**FINAL DRAINAGE REPORT
FOR
A-1 CHIPSEAL
LOT 36 AND 37 CLAREMONT BUSINESS PARK FIL NO 2
7245 COLE VIEW
COLORADO SPRINGS, COLORADO**

MAY 2022

"PCD File No.
COM-22-014"

SITE MAP

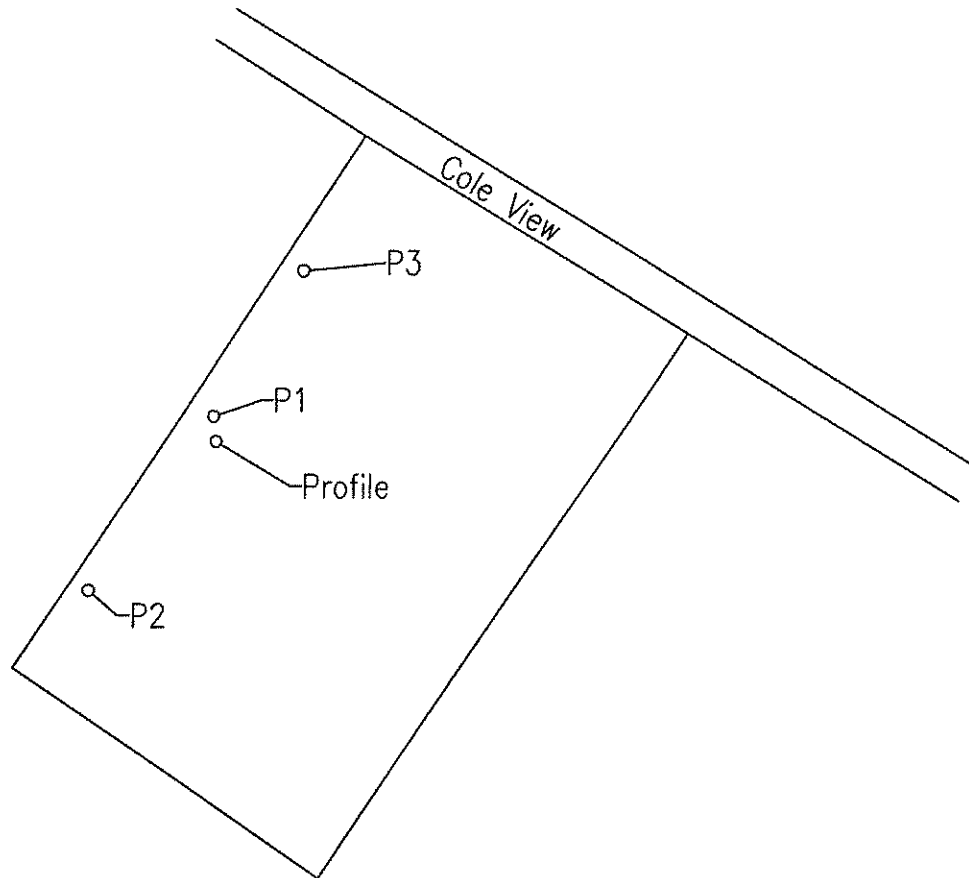
This percolation test is for
Lot 11. Lots 36 and 37 are
discussed in this report.
Please revise or remove
report. Additionally, discuss
in the narrative why the
percolation test is included.

Correct report has now been included.
Water quality narrative has been
revised to discuss need for
percolation test.

EXISTING DRAINAGE MAP

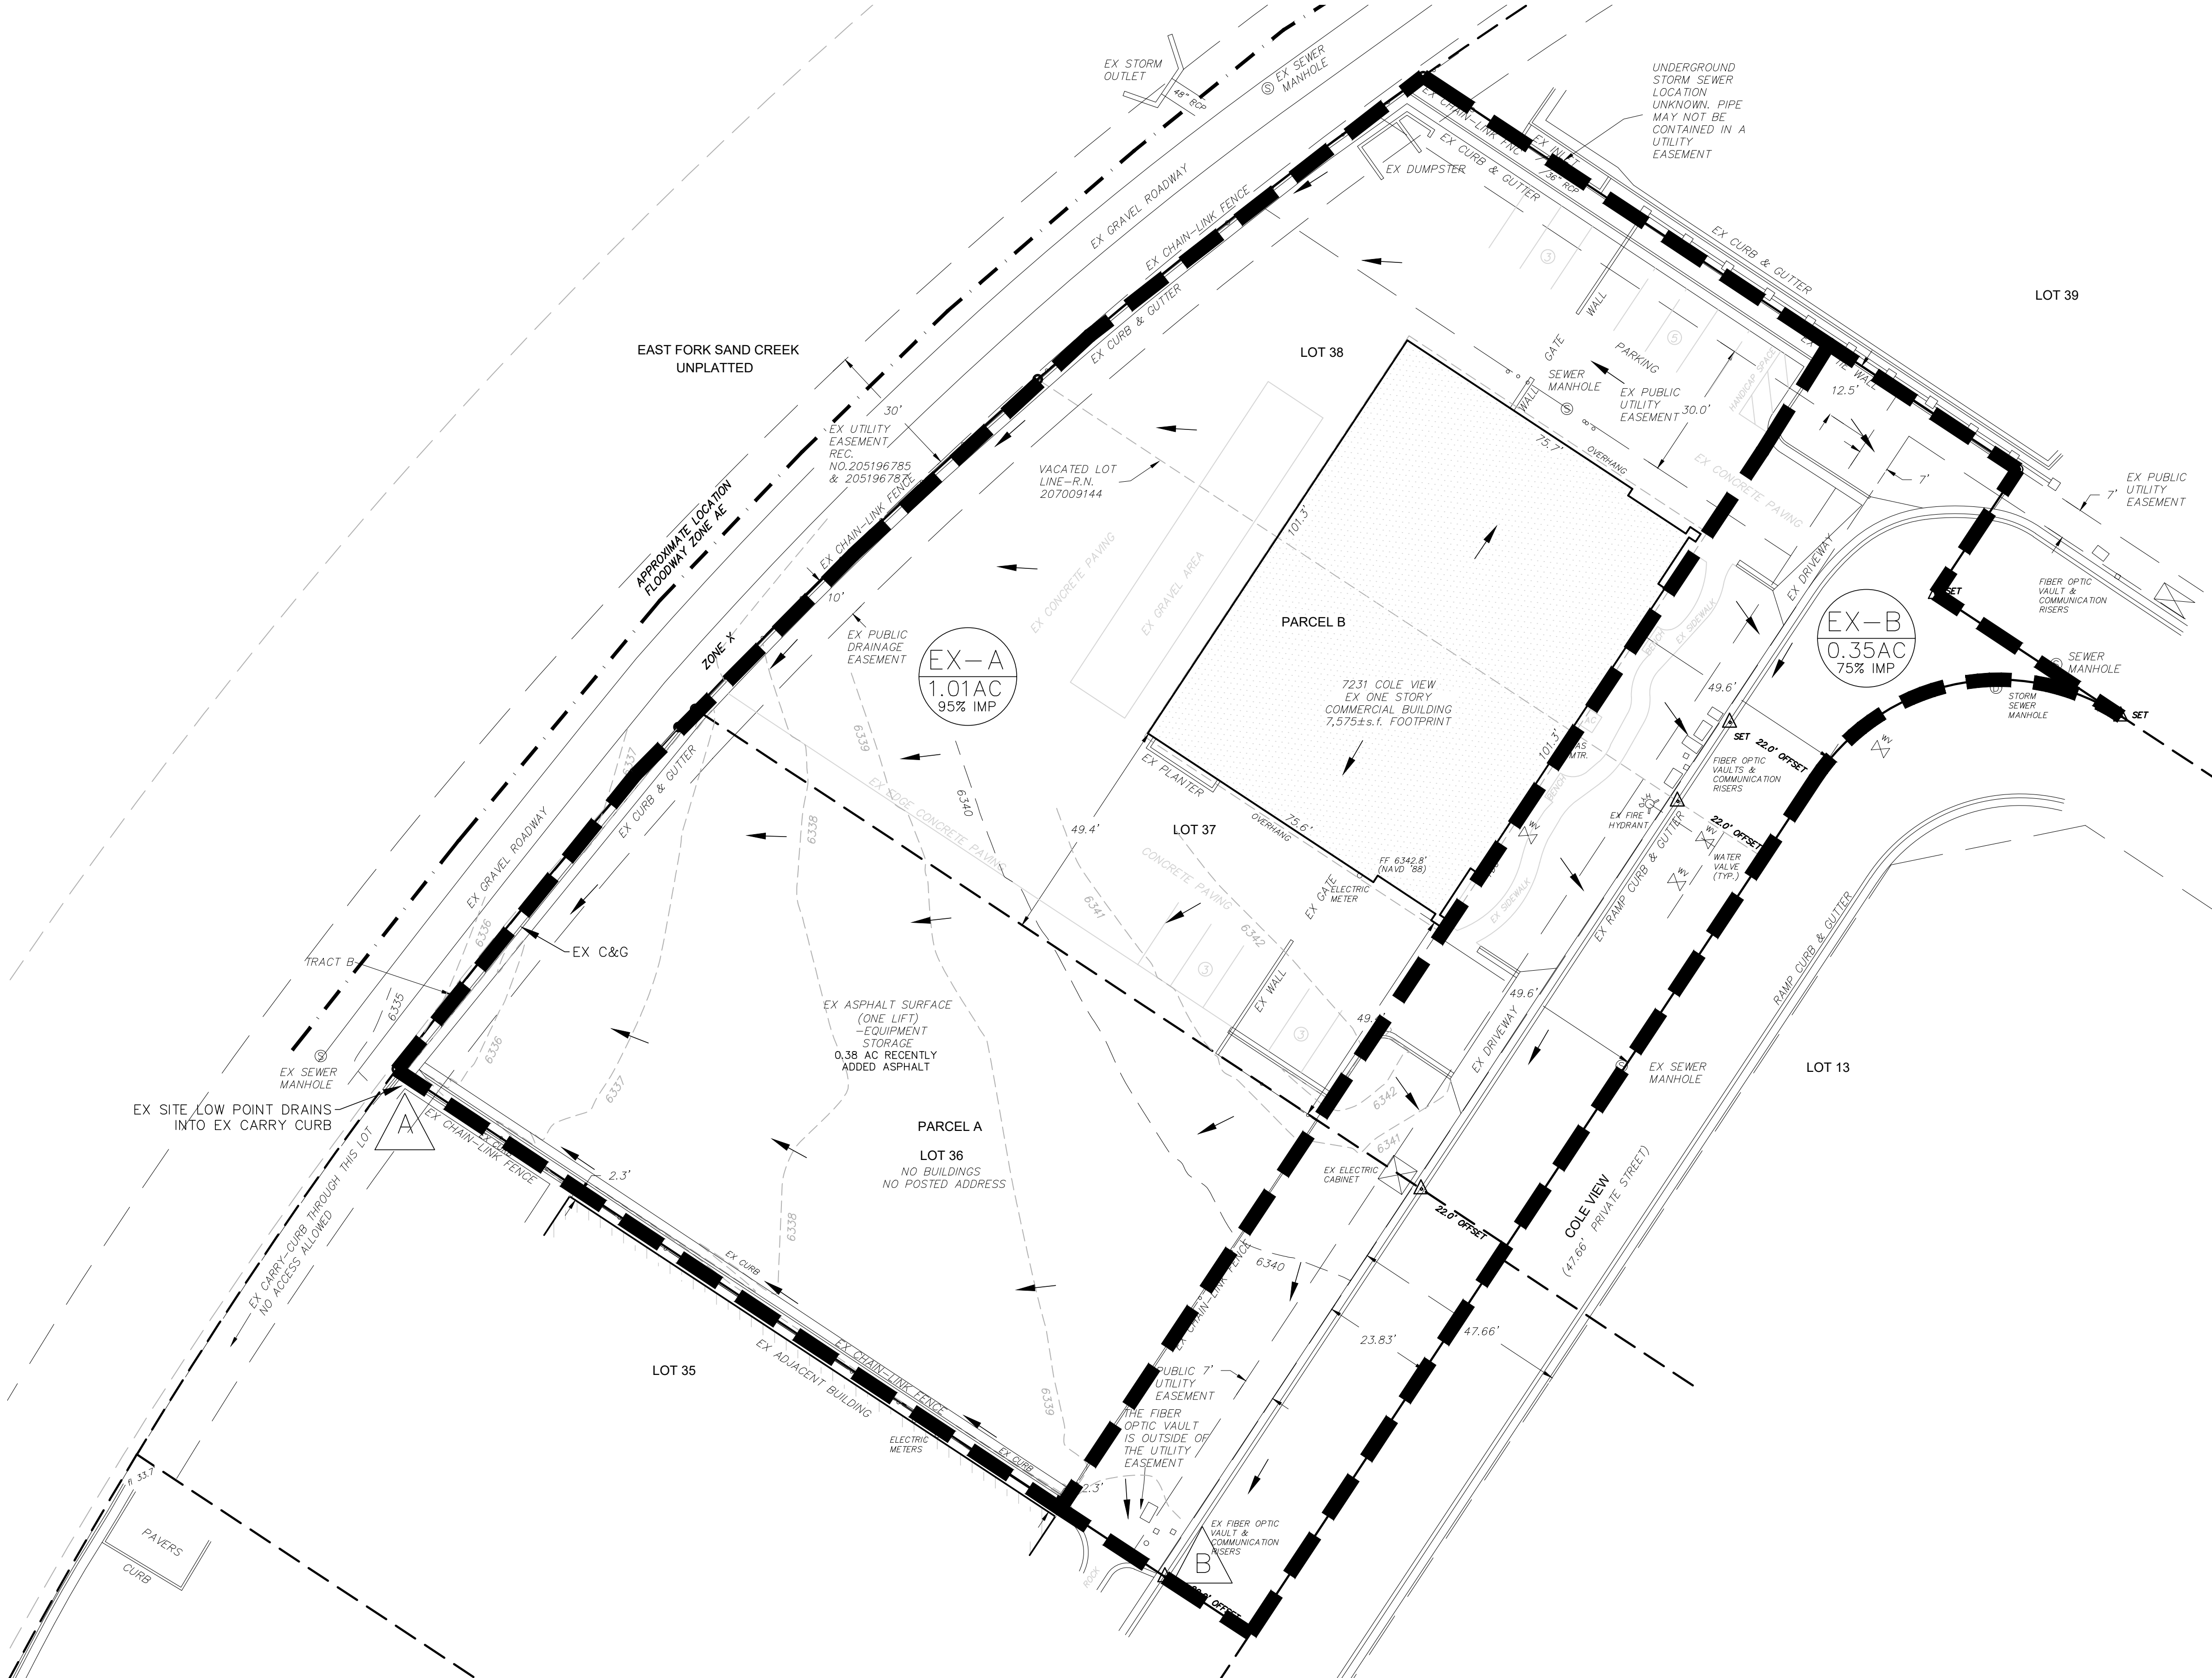
Please show the time of concentration path and update the legend.

LEGEND AND
PLAN UPDATED.

PROPOSED DRAINAGE MAP

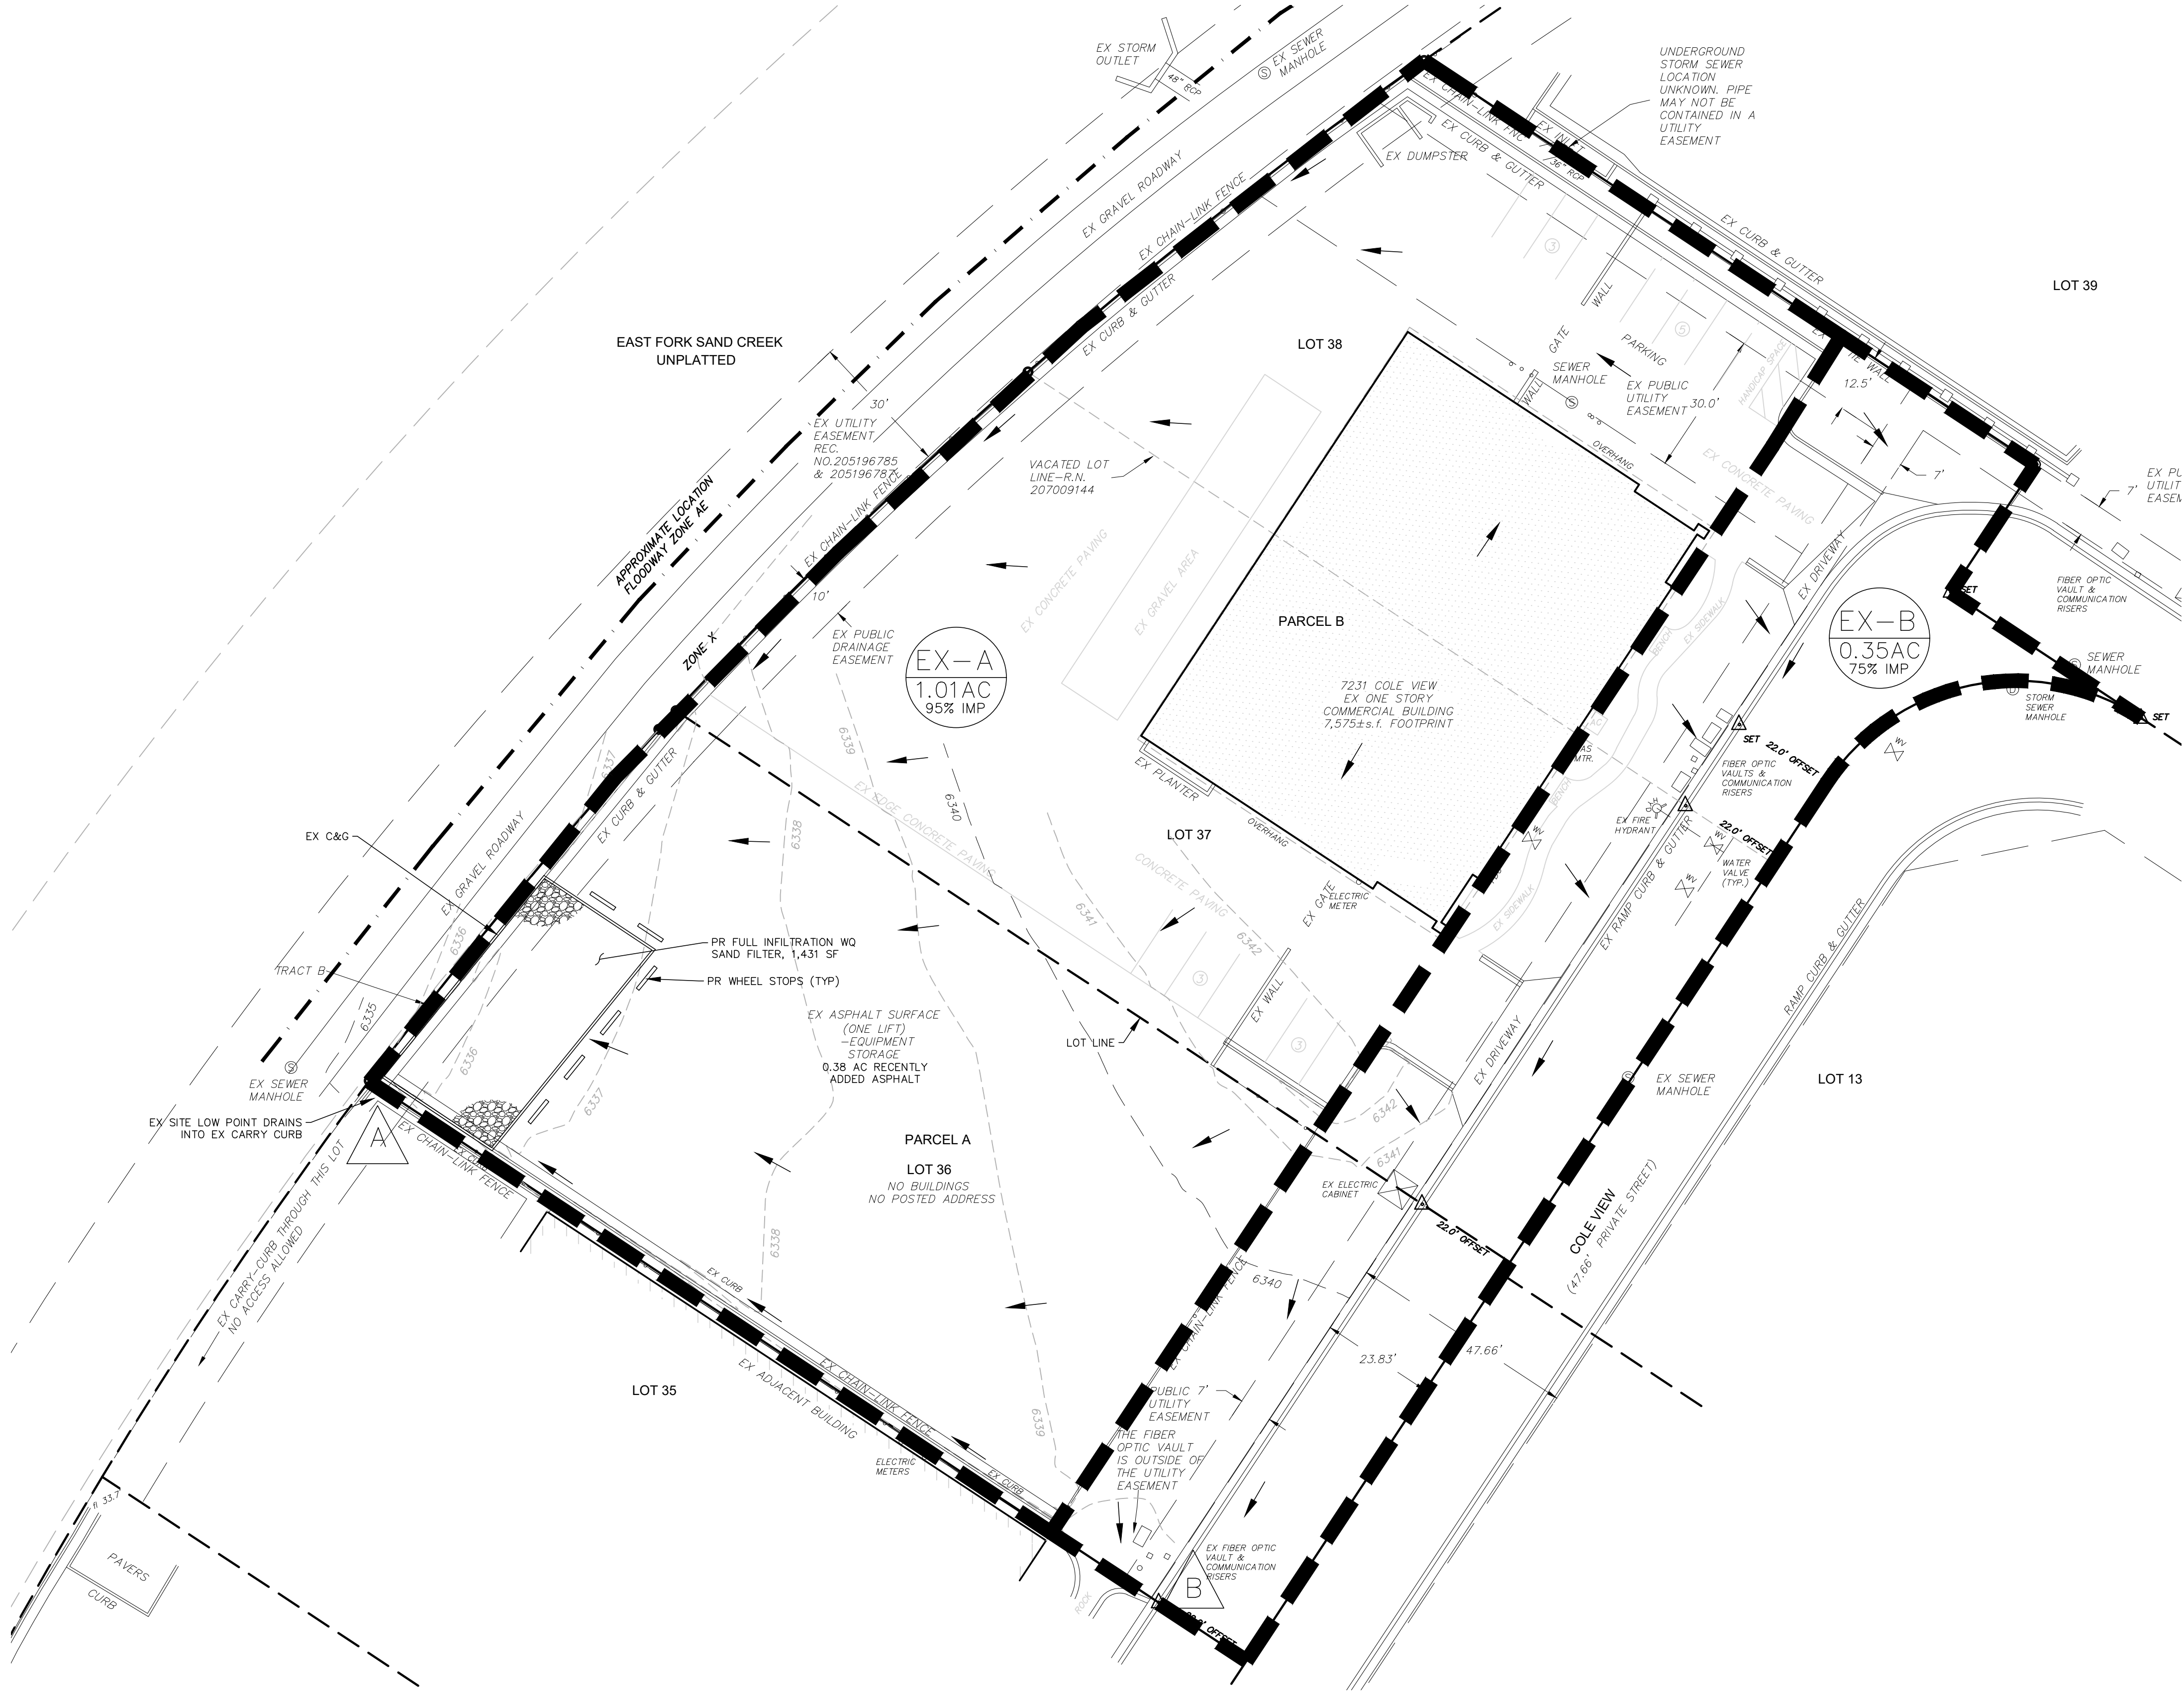
Please show the time of concentration path and update the legend.

LEGEND AND PLAN UPDATED.
